Access Compliance Report

Public Rights-of-Way

(Curb Ramps)

Intersection ID: 10023486	Main Street: CIRCUMFERENTIAL_RD	Cross Street: N/A	Location: SW
ADA ID: 090D12BFA8A4	Ramp Type: Perp	Initial Pass/Fail: Fail	Overall Compliance: No
Severity Score: 21.25			
Codes/Mitigation Info/Possible Solution		Field Measurements/Component Compliance

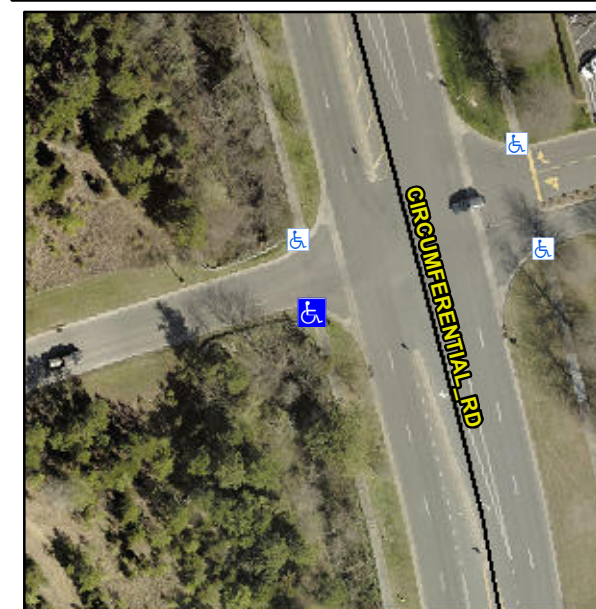
R304.5.1, R304.5.3

Compliance	Description	Data	Compliance	Description	Data
N/A	Ramp Length (in)	45.0	Yes	Ramp Slope (%)	3.1
No	Ramp Width (in)	45.0	No	Ramp XSlope (%)	5.4
N/A	Flare Type LT	N/A	N/A	Flare Type RT	N/A
N/A	Flare Slope LT (%)	N/A	N/A	Flare Slope RT (%)	N/A
N/A	Flare Traversable LT?	N/A	N/A	Flare Traversable RT?	N/A
N/A	Landing Length (in)	N/A	N/A	DWS Provided?	N/A
N/A	Landing Width (in)	N/A	N/A	DWS Contrast?	N/A
N/A	Landing Slope (%)	N/A	N/A	DWS Length (in)	N/A
N/A	Landing X Slope (%)	N/A	N/A	DWS Full Width?	N/A
N/A	Landing Curb? (Y/N)	N/A	N/A	DWS Offset (in)	N/A
N/A	Shared Landing?	N/A			
N/A	Gutter Ponding?	N/A	N/A	Gutter Slope (%)	N/A
N/A	Gutter Lip Ht (in)	N/A	N/A	Gutter X Slope (%)	N/A
N/A	Painted X Walk1?	No	N/A	Painted X Walk2?	N/A
	X Walk 1 Direction	To N		X Walk 2 Direction	N/A
N/A	X Walk 1 Width (in)	N/A	N/A	X Walk 2 Width (in)	N/A
	X Walk 1 Slope (%)	1.8		X Walk 2 Slope (%)	N/A
	X Walk 1 X Slope (%)	3.6		X Walk 2 X Slope (%)	N/A

Remove & Replace Entire Ramp.
